CITY OF ROCKWALL, TEXAS

QUAIL RUN LIFT STATION
SITE PLAN AND ABANDONMENT PLAN

DESIGNED BY: P.A.C.	PROJECT: 2000172	SHEET NO. 6
DRAWN BY: J.P.O.	DATE: DECEMBER, 2002	OF 8 SHEETS

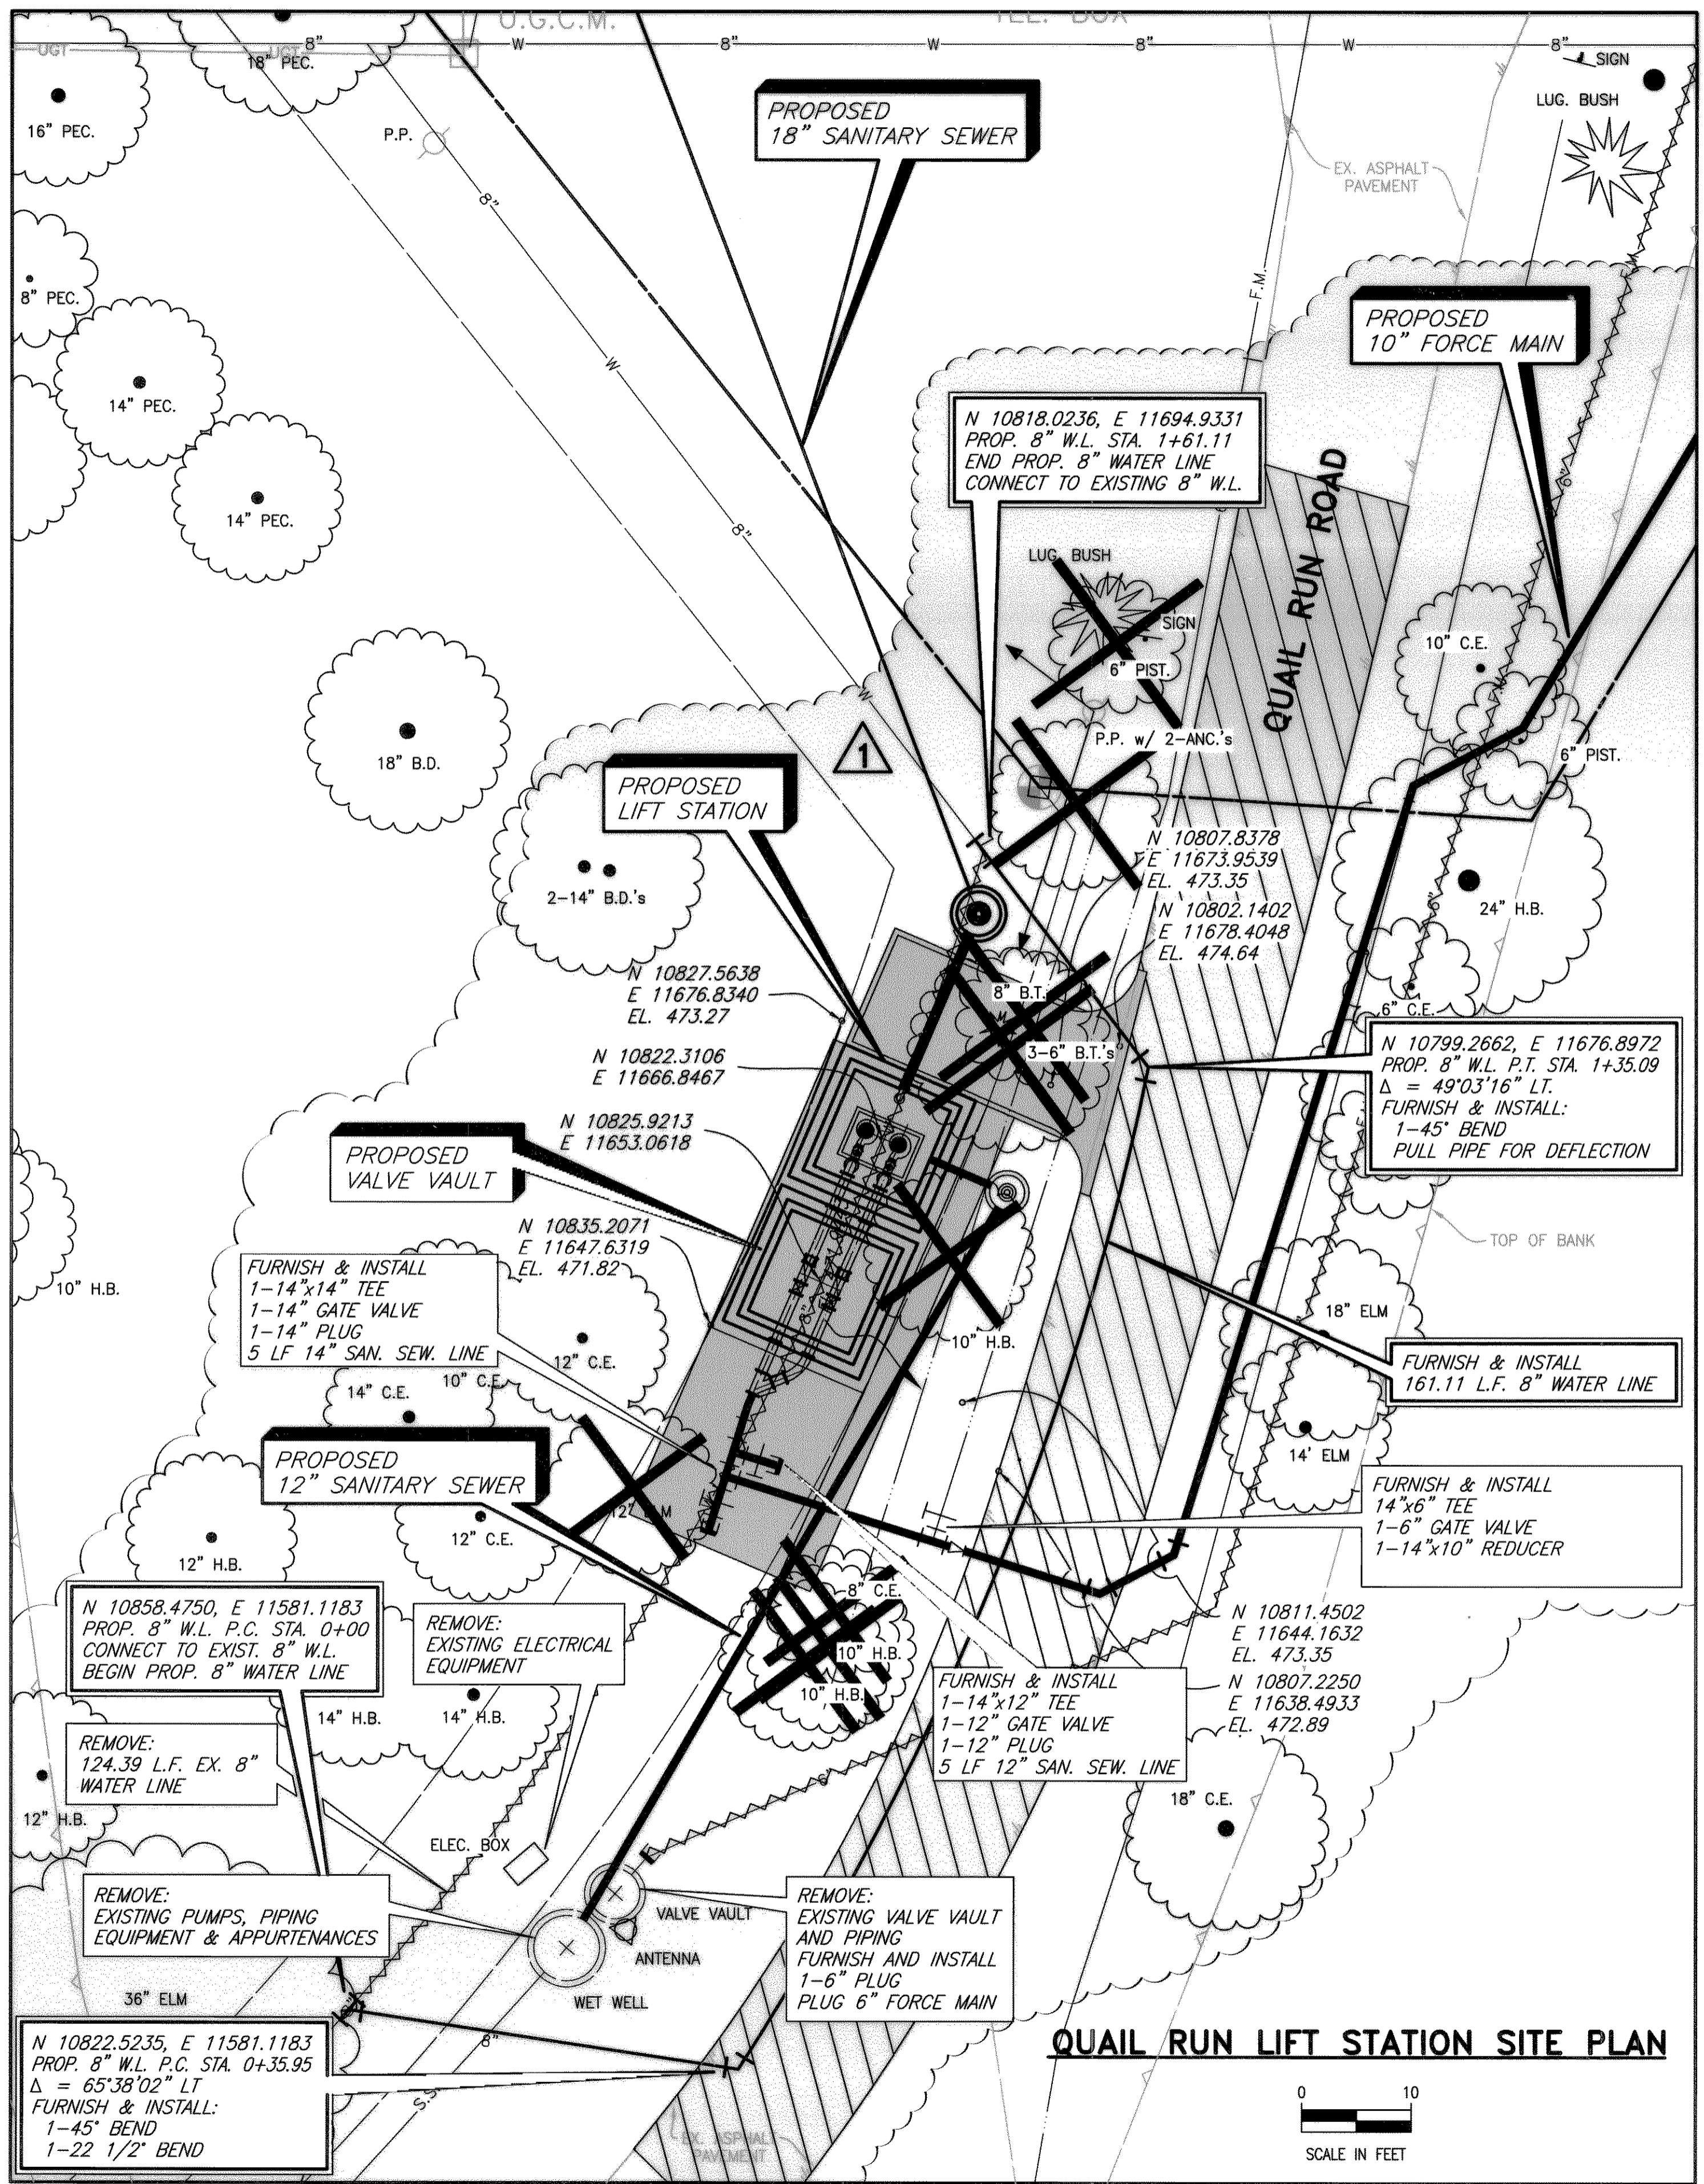
CHANGE ORDER NO. 1
12/13/2002 REVISED LIFT STATION LOCATION
